MILITARY SPECIFICATION

CASE, BATTERY COMMAND PERISCOPE: M165

This amendment forms a part of Military Specification MIL-C-60226(MU), dated 7 May 1965.

FIGURE 1-CASE ASSEMBLY

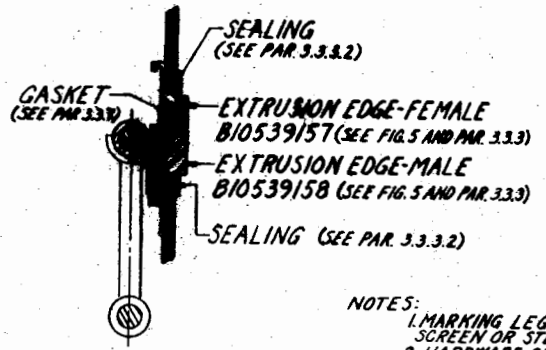
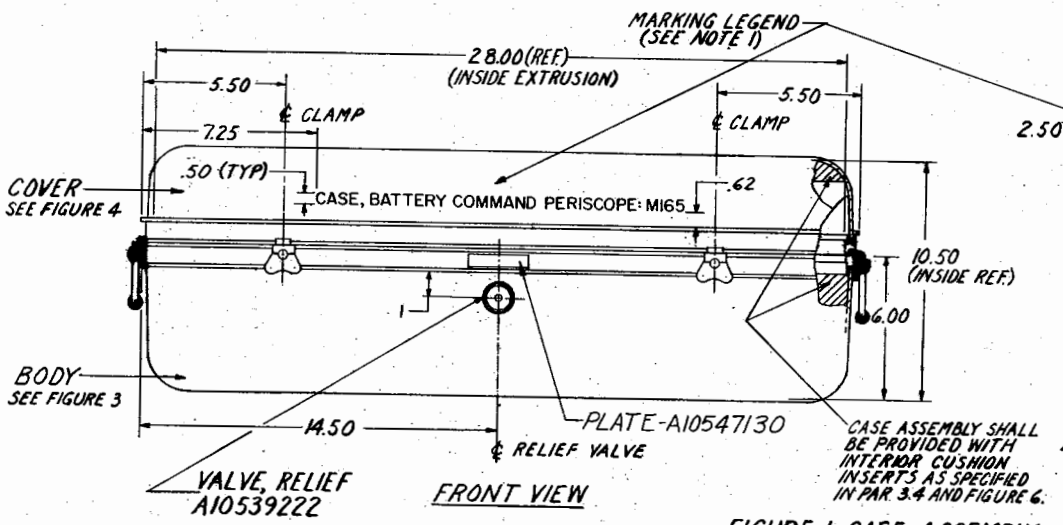
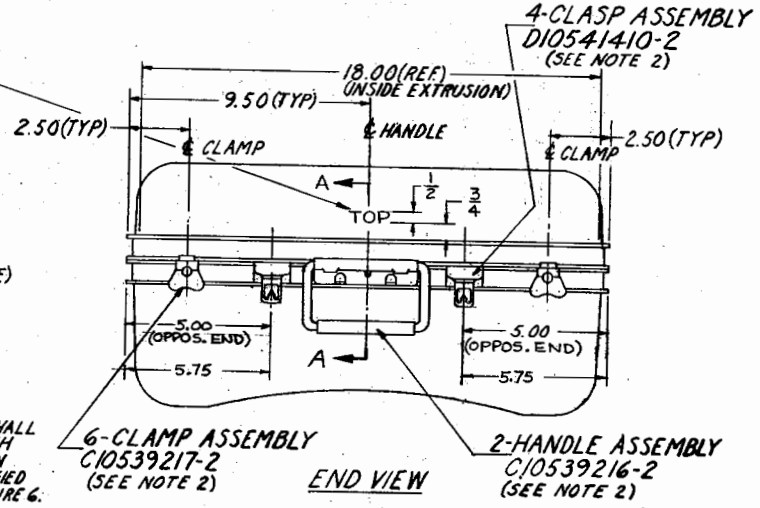
* Delete: "Figures 1, 6, 7 and 8" and substitute attached "Figures 1, 6, 7 and 8."
